### URGENT IMPORTANT FIELD SAFETY NOTIFICATION

**Subject:** Potential incorrect positioning after verification scan

**Product:** iGUIDE® Software 2.2

Scope: iGUIDE® 2.2.0, iGUIDE® 2.2.1

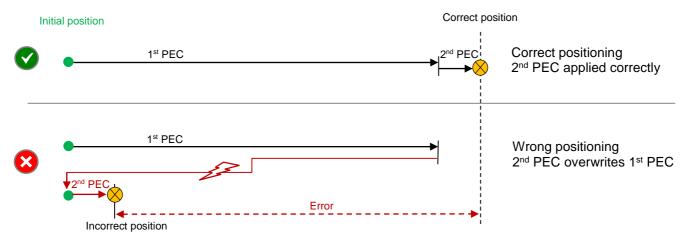
If the PEC data dialog after a verification scan is cancelled, a re-send of PEC data will lead to incorrect positioning because the 2<sup>nd</sup> PEC values supersede the 1<sup>st</sup> PEC values instead of being added.

The following image compares the iGUIDE workflow scenarios with correct and incorrect positioning.

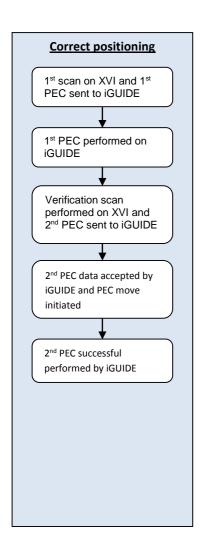
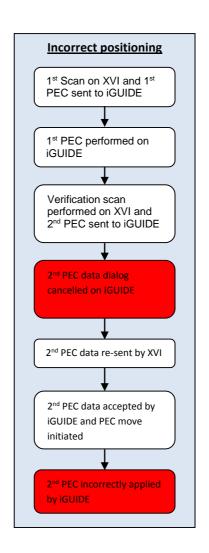
- On the left a normal workflow including verification scan with correct positioning is shown.
- On the right the unusual workflow with wrong positioning is shown. The error occurs when the 2<sup>nd</sup> PEC data dialog is cancelled and the re-sent PEC is executed.

Do not cancel the 2<sup>nd</sup> iGUIDE PEC data dialog (and confirm the cancellation) for a verification scan.

If you have cancelled the 2<sup>nd</sup> PEC data dialog, you have to restart the positioning and return to the beginning of
